Service Bulletin

Subject: Malfunction Indicator Lamp (MIL) ON, Reduced Power Mode and DTCs

Brand:	Model:	Model Year:		VIN:		Engine:	Transmission:
		from	to	from	to		
Chevrolet, GMC	Equinox, Terrain	2010	2015			All	All

Accelerator Pedal Position (APP) Sensor assembly (1) and APP harness (2)

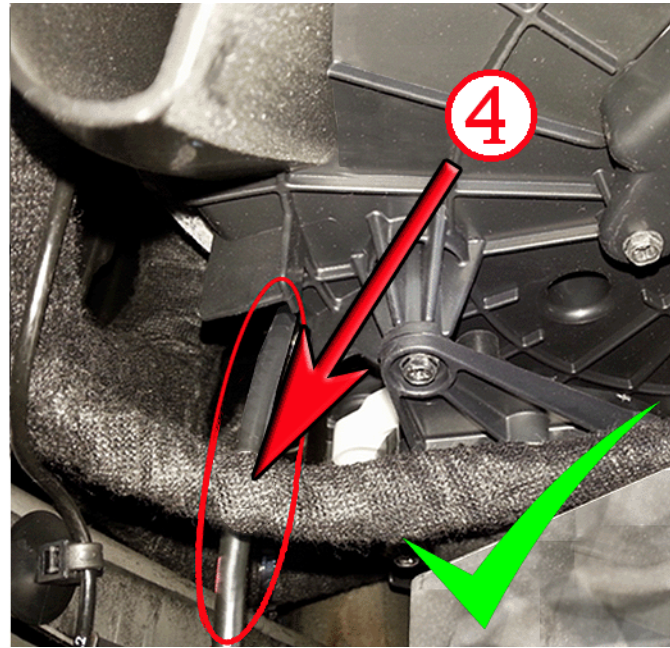
Condition	Some customers may comment that the Malfunction Indicator Lamp (MIL) is ON, Reduced Power Mode active, along with DTCs.
Cause	The Accelerator Pedal Position (APP) Sensor wiring harness may be mis-routed and under tension, damaging the connector, causing a poor connection.

1. Inspect the Accelerator Pedal Position (APP) Sensor harness connector B104 (2) for fretting or damage and for proper routing. If damage found, proceed to Step 2. If no damage found, follow normal SI diagnostics.
2. Replace the Accelerator Pedal Position (APP) Sensor assembly (1). Refer to *Accelerator Pedal with Position Sensor Assembly Replacement* in SI.
3. Replace the Accelerator Pedal Position (APP) Sensor harness (2) and ensure the correct routing (4). The harness must be routed below the Onstar® coax cable. Refer to *Splicing Copper Wire Using Splice Sleeves* in SI.
4. Verify the repair. Refer to *Diagnostic Repair Verification* in SI.

Replace Accelerator Pedal Position (APP) Sensor assembly part number 25798449, and APP harness part number 13584094. Reroute the harness.
